Subject: Response to Weber Fire District Plan Review

Project Name: Cedar Cove Estates 4th Amend Access Easement

Project Address: 6696 S 2850 E, Uintah, UT 84403

Plan Review

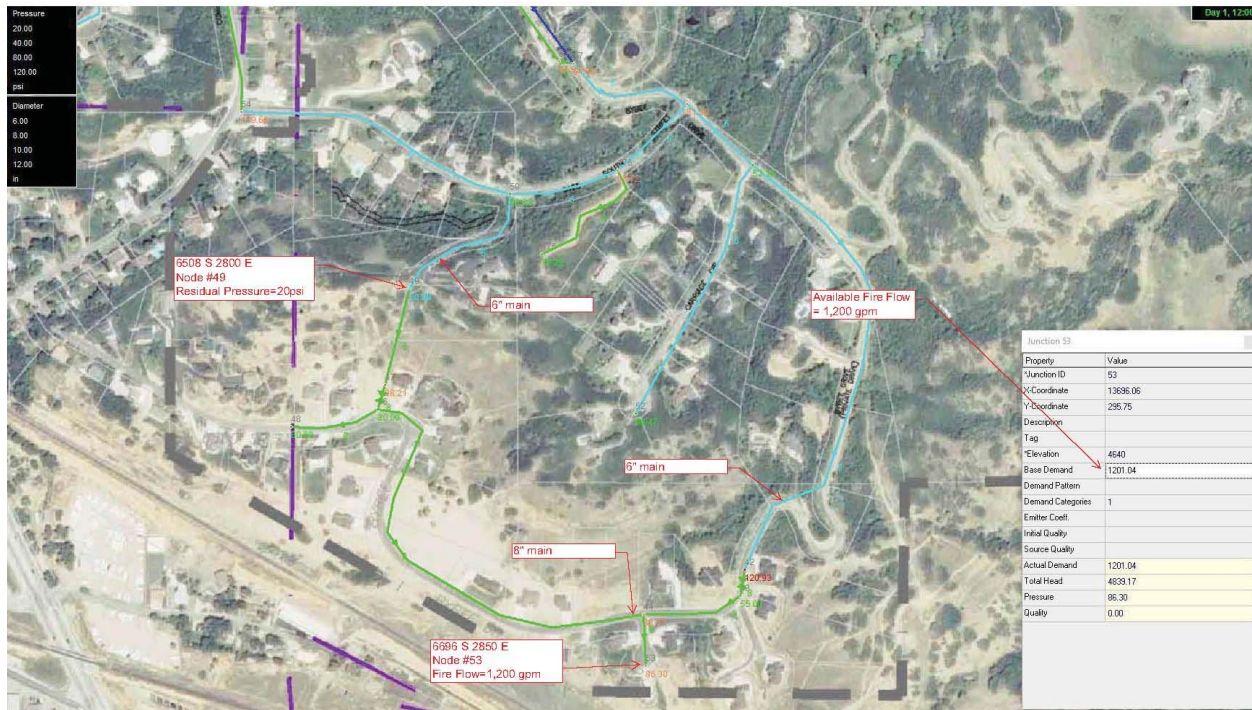
The model indicates that the normal operating pressure of the system at this location is 97 psi. The water model also indicates that the available fire flow is 1,200 gallons per minute with a residual pressure of 20 psi on the system. The residual pressure of 20 psi occurs at the top of the hill at 6508 South 2800 East to the northwest of the lot (or node #49) rather than at the proposed lot (node #53). Flows in excess of 1,200 gallons per minute at the proposed lot will cause the system pressure to drop below 20 psi in the area at the top of the hill (node #49). See the image below:
